Attachment A
TRAFFIC IMPACT STUDY – SCOPE APPROVAL FORM

Thunderhead Beach
 Steamboat Springs, Colorado
 Project Trip Distribution

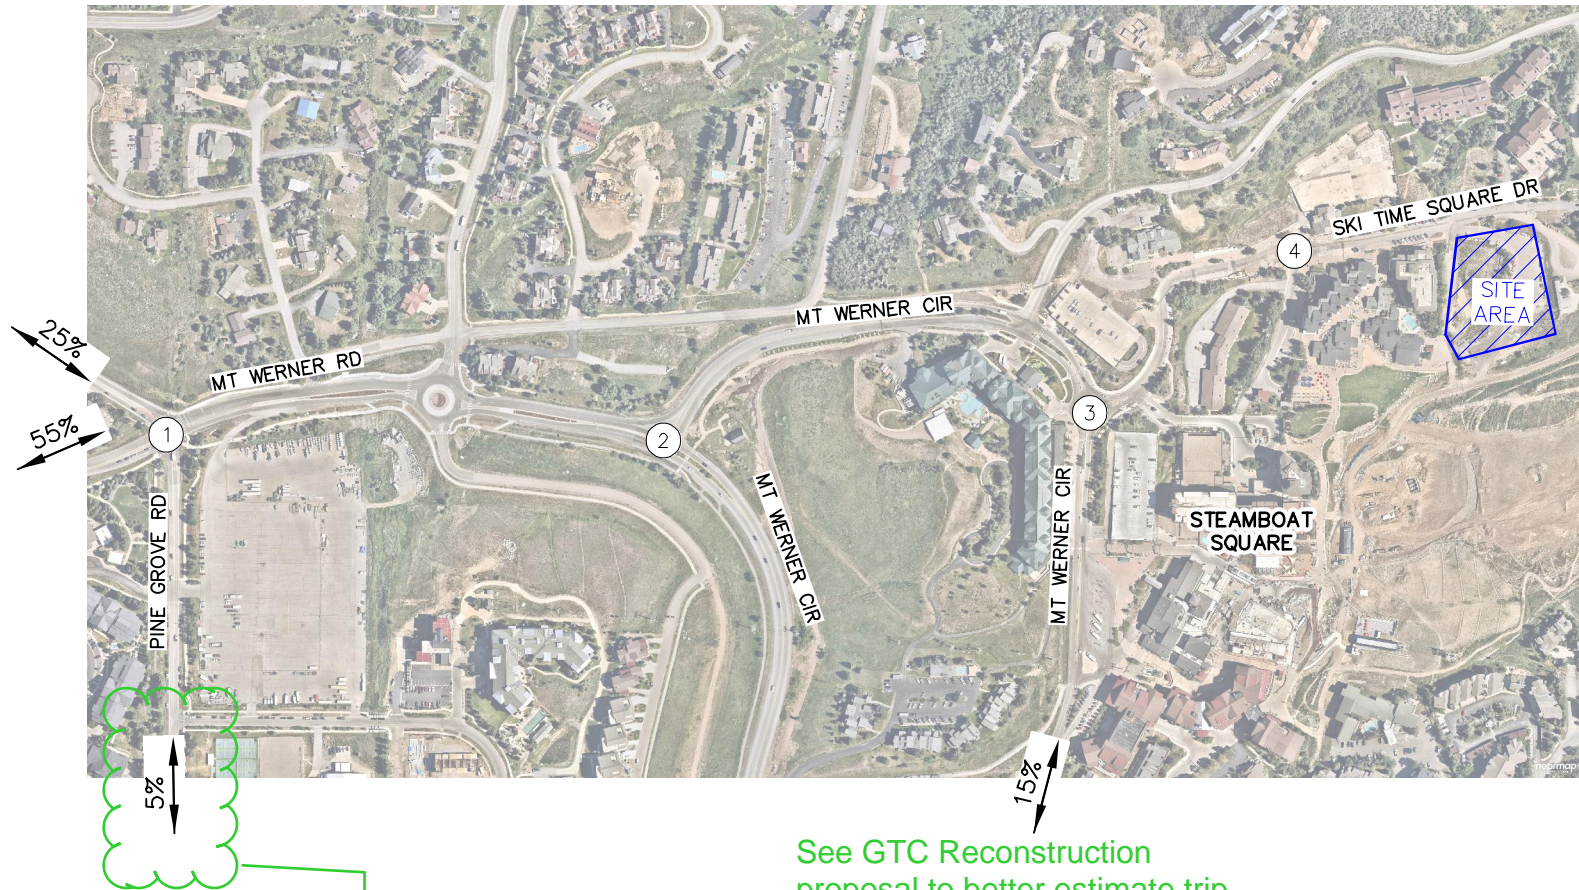
See GTC Reconstruction proposal to better estimate trip distribution percentages.

This percentage distribution should be redistributed to Mt. Werner Rd calculation as the US 40/Pine Grove intersection is proposed to be reconstructed as a restricted Right in/Right out.
